GUSSIE NELL DAVIS
RANGERETTE RESIDENCE
KILGORE COLLEGE

Addendum No. 1
to the Proposal Documents for
GUSSIE NELL DAVIS RANGERETTE RESIDENCE
KILGORE COLLEGE
Kilgore, Texas

Addendum No. 2
to the Proposal Documents for
GUSSIE NELL DAVIS RANGERETTE RESIDENCE
KILGORE COLLEGE
Kilgore, Texas

Addendum No. 3
to the Proposal Documents for
GUSSIE NELL DAVIS RANGERETTE RESIDENCE
KILGORE COLLEGE
Kilgore, Texas

BS01- AREA "A" SCALE: 1/4" = 1'-0" FILE: BS01

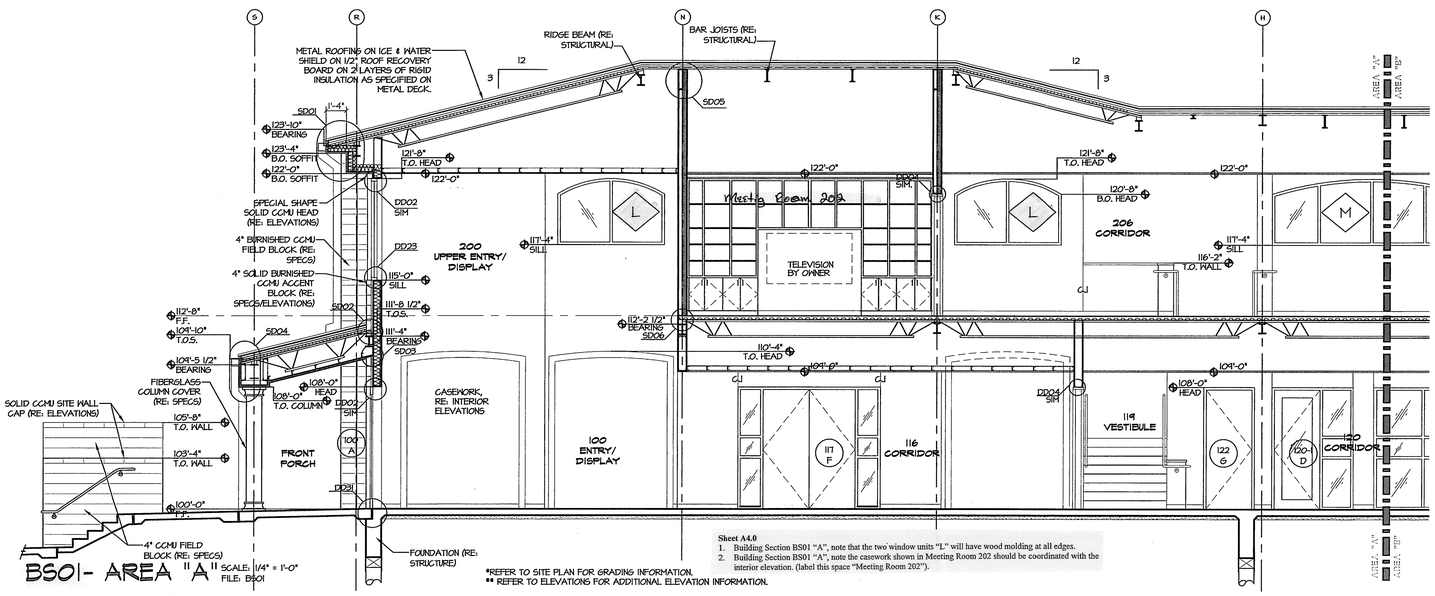
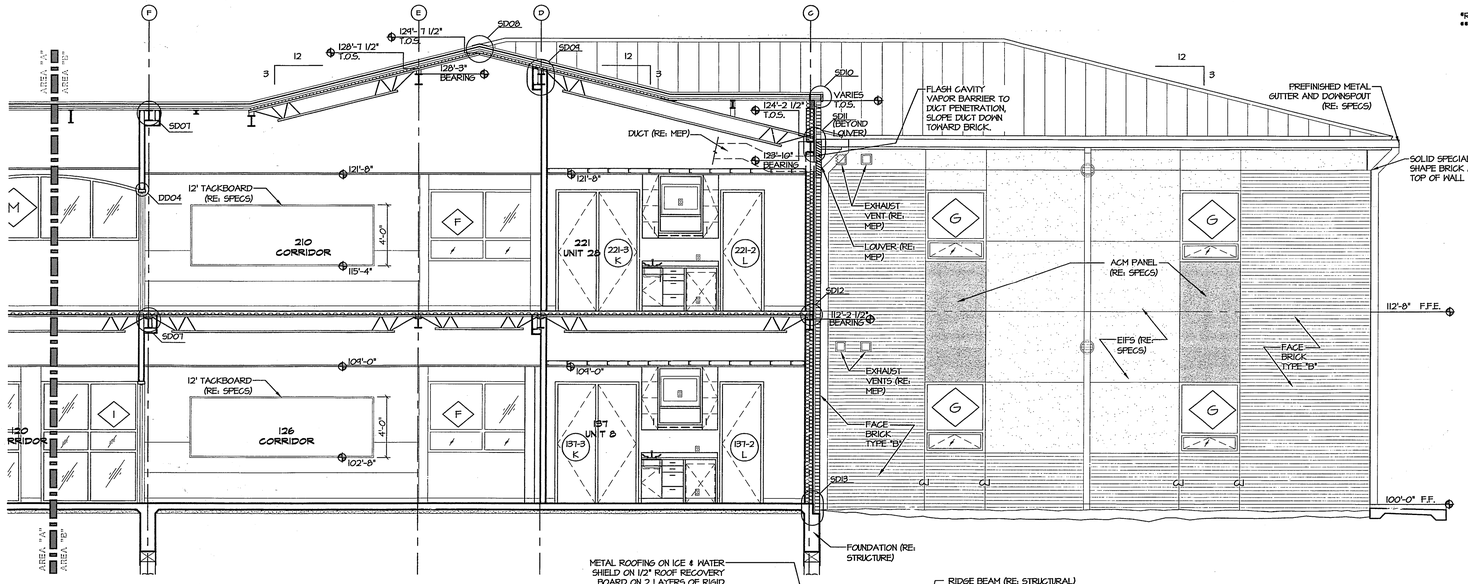
Sheet A4.0
1. Building Section BS01 "A", note that the two window units "L" will have wood molding at all edges.
2. Building Section BS01 "A", note the casework shown in Meeting Room 202 should be coordinated with the interior elevation. (label this space "Meeting Room 202").

Sheet A4.0
1. Building Section BS01, note to show 6 ¼" batt insulation at the soffit framing at all soffit conditions (all soffits will be fully insulated including vertical fascia sections and to remain open to the building plenum).
2. Building Section BS03, note to 6 ¼" show batt insulation at the soffit framing at all soffit conditions (all soffits will be fully insulated including vertical fascia sections and to remain open to the building plenum).
3. Section Detail SD03, note to show 6 ¼" batt insulation at the studs for the exterior soffit.
4. Section Detail SD04, note to show 6 ¼" batt insulation at the studs for the exterior soffit/fascia framing.

BS04 SCALE: 1/4" = 1'-0" FILE: BS04

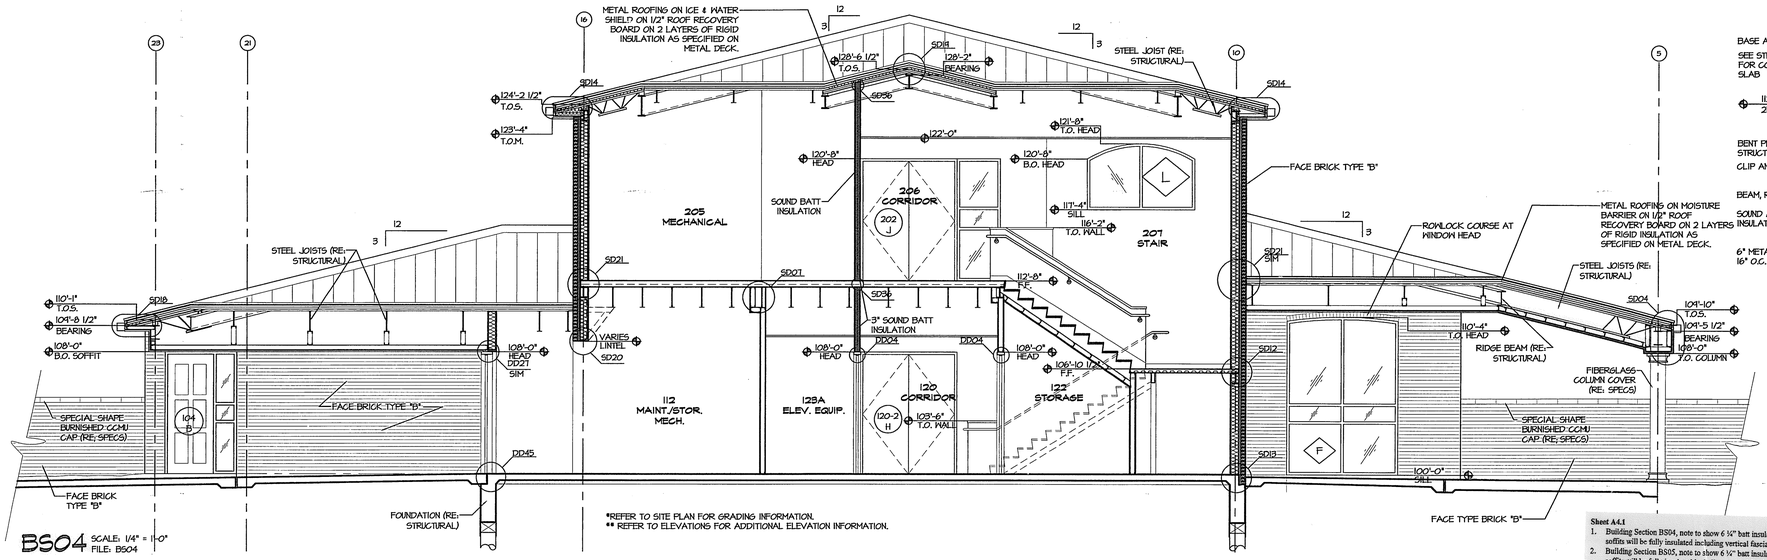
Sheet A4.1
1. Building Section BS04, note to show 6 ¼" batt insulation at the soffit framing at all soffit conditions (all soffits will be fully insulated including vertical fascia sections and to remain open to the building plenum).
2. Building Section BS05, note to show 6 ¼" batt insulation at the soffit framing at all soffit conditions (all soffits will be fully insulated including vertical fascia sections and to remain open to the building plenum)

BS10 SCALE: 1/4" = 1'-0" FILE: BS10

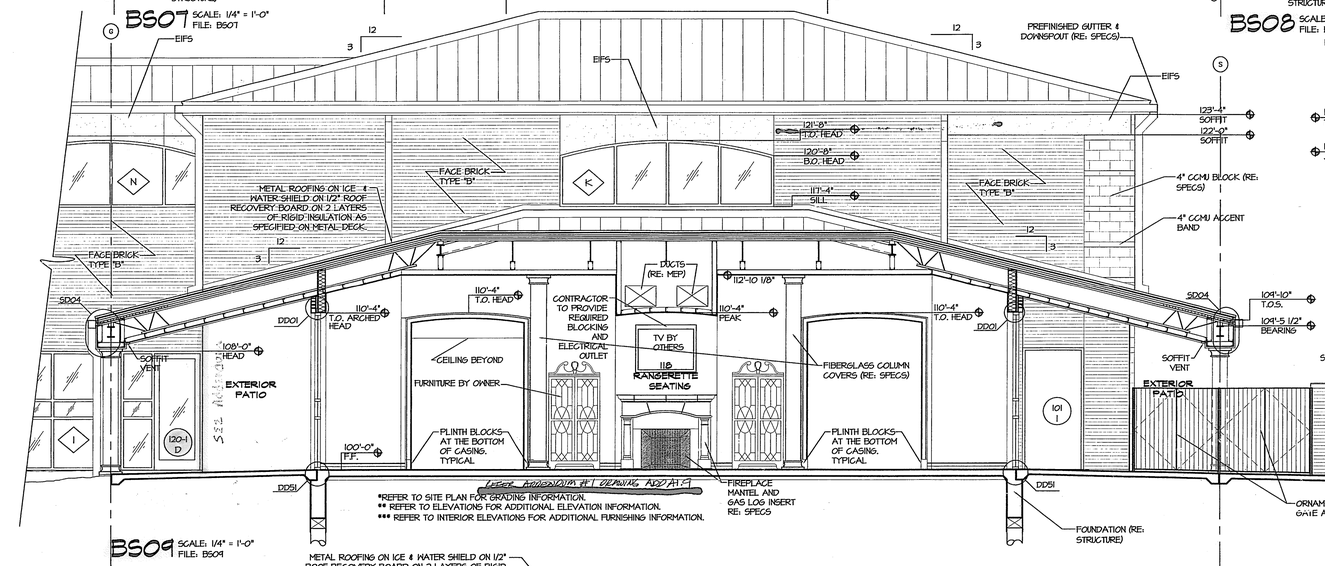
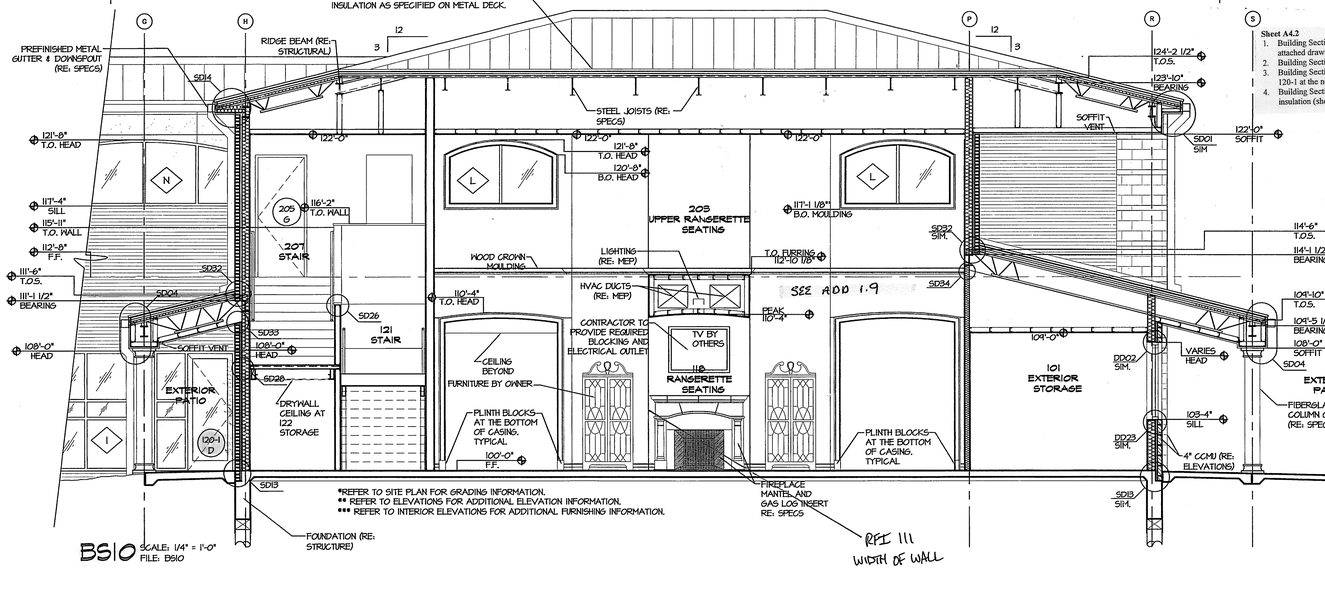
1. Building Section BS10, note to revise the interior elevation condition shown in Rangerette Seating 118 per attached drawing ADD1.9.
2. Building Section BS10, coordinate door 120-1 with actual door type.
3. Building Section BS09, coordinate door 120-1 with actual door type. Note the wall area to the right of door 120-1 at the note "Exterior Patio" is face brick and should be shown accordingly.
4. Building Section BS07, exterior wall of Unit 21 Room 214, note the exterior wall to have specified thermal insulation (show in wall accordingly).

BS14 SCALE: 1/4" = 1'-0" FILE: BS14

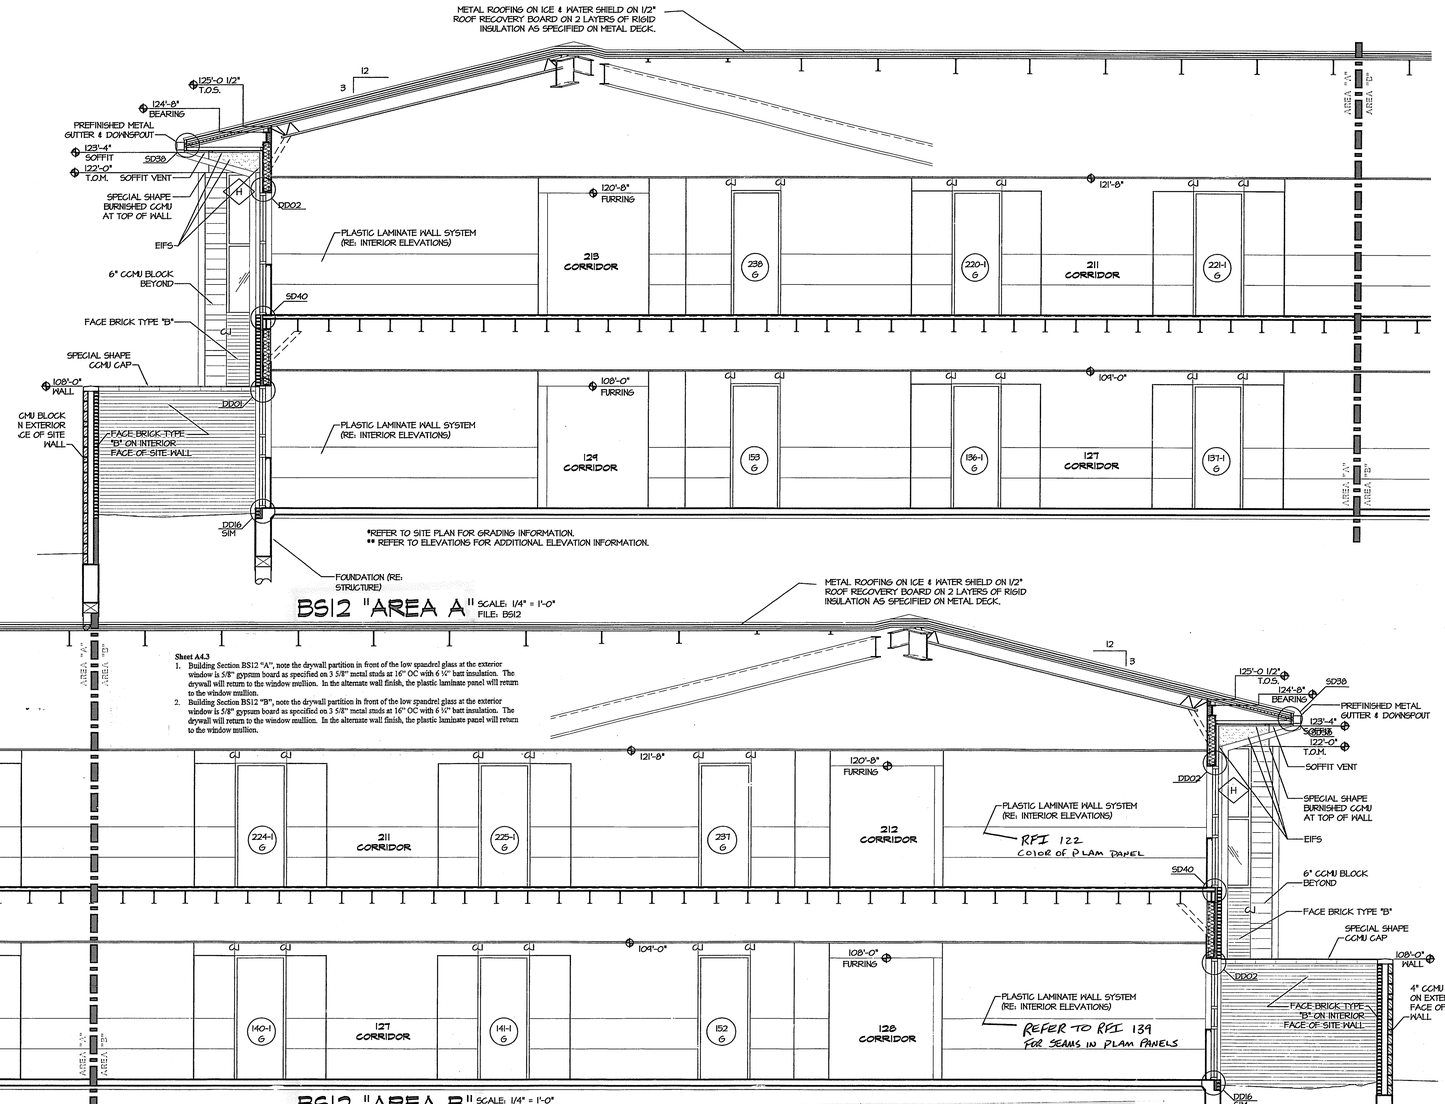
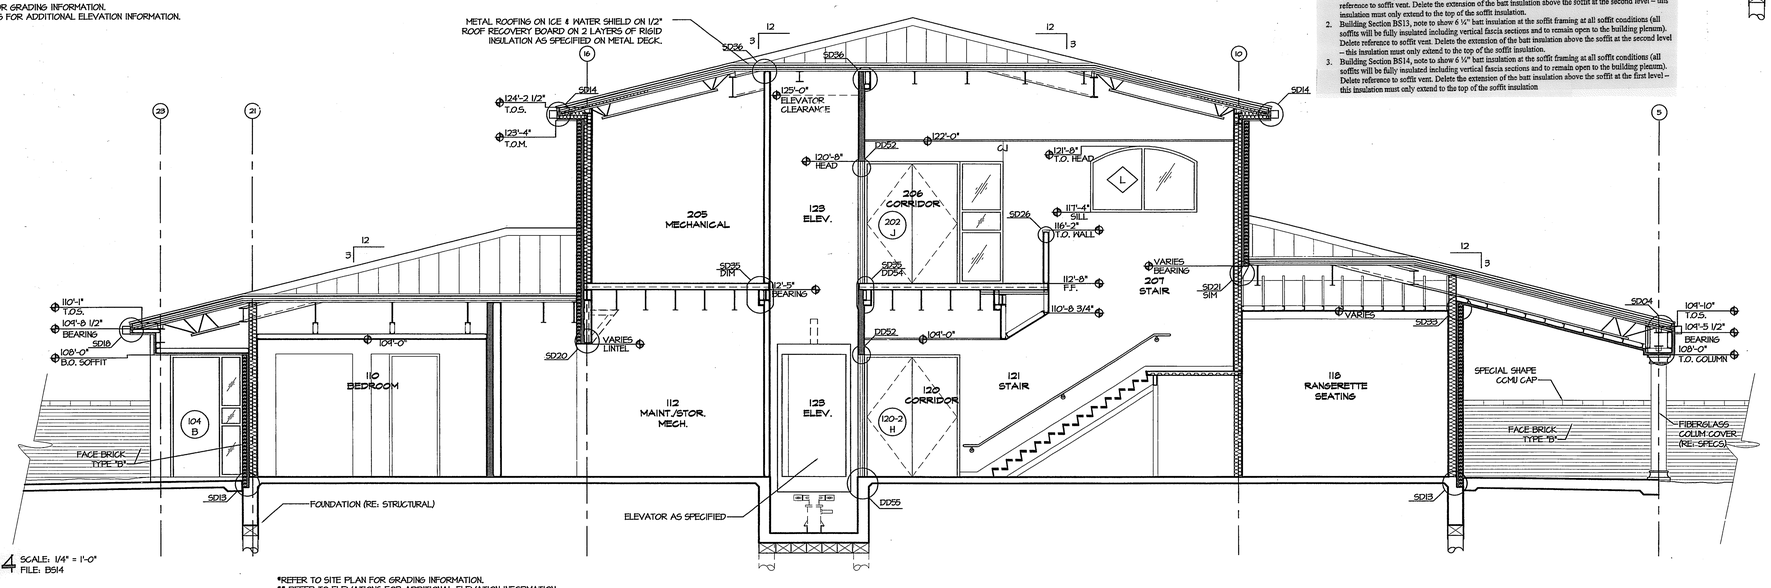
2. Building Section BS13, note to show 6 ¼" batt insulation at the soffit framing at all soffit conditions (all soffits will be fully insulated including vertical fascia sections and to remain open to the building plenum). Delete reference to soffit vent. Delete the extension of the batt insulation above the soffit at the second level – this insulation must only extend to the top of the soffit insulation.

3. Building Section BS14, note to show 6 ¼" batt insulation at the soffit framing at all soffit conditions (all soffits will be fully insulated including vertical fascia sections and to remain open to the building plenum). Delete reference to soffit vent. Delete the extension of the batt insulation above the soffit at the first level – this insulation must only extend to the top of the soffit insulation

A 7.0

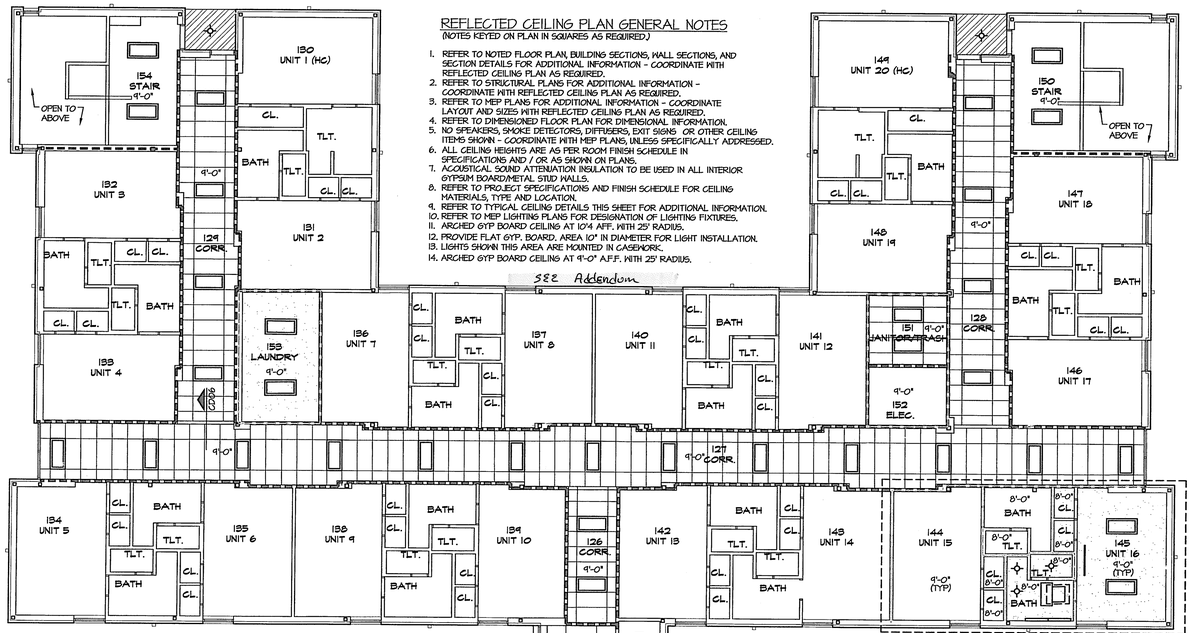
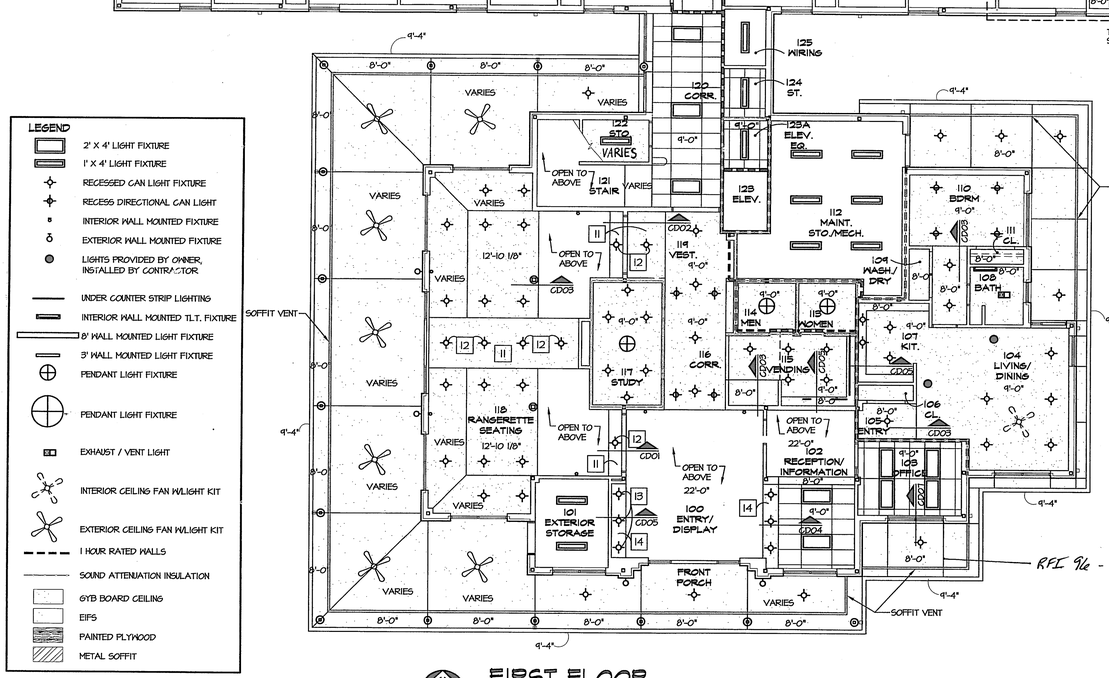
1. Ceiling Details CD01/02, note wood trim and molding at opening.
2. Delete ceiling detail CD07.
3. First Floor Reflected Ceiling Plan, delete reference to CD07 in Office 103.
4. Reflected Ceiling Plan, note that all rated partitions will have sound attenuation insulation in addition to the rooms as defined.

1. Reflected Ceiling Plan, delete reference to soffit vents as noted/shown. The EIFS soffit will be continuous without venting. The soffit plenum will be open to the interior ceiling plenum in all cases. The soffit/fascia framing will have 6 ½" batt insulation installed for a continuous thermal barrier from exterior wall to soffit to roofline. Coordinate drywall sound barriers at the soffit plenum as outlined on the attached drawing ADD3.1. In all cases the sound barriers will be constructed out of the same partition type as the wall being extended.
2. Ceiling Detail CD04, revise the listed furring elevation "VARIES" to read "MATCH CD05".
3. Ceiling Detail CD05, revise the listed furring elevation "SEE PLAN" to read "COORDINATE WITH CASEWORK INSTALLATION".

Sheet A7.1
1. Reflected Ceiling Plan, note that all rated partitions will have sound attenuation insulation in addition to the rooms as defined.

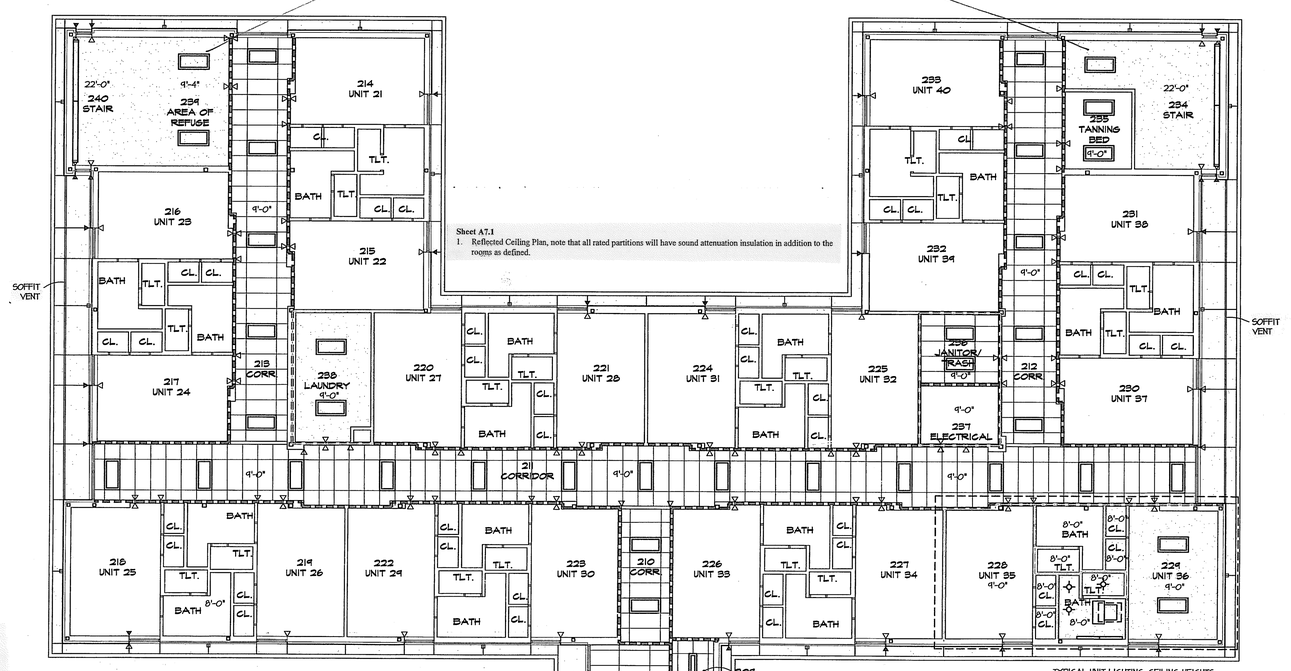
Sheet A7.1
1. Reflected Ceiling Plan, note the west wall of Storage 204 should not be listed as a rated partition.
2. Reflected Ceiling Plan, Meeting Room 202, show six recessed can light fixtures as added this addendum by the MEP attachment.

Sheet A7.1
1. Reflected Ceiling Plan, delete reference to soffit vents as noted/shown. The EIFS soffit will be continuous without venting. The soffit plenum will be open to the interior ceiling plenum in all cases. The soffit/fascia framing will have 6 ¼" batt insulation installed for a continuous thermal barrier from exterior wall to soffit to roofline. Coordinate drywall sound barriers at the soffit plenum as outlined on the attached drawing ADD3.1. In all cases the sound barriers will be constructed out of the same partition type as the wall being extended.
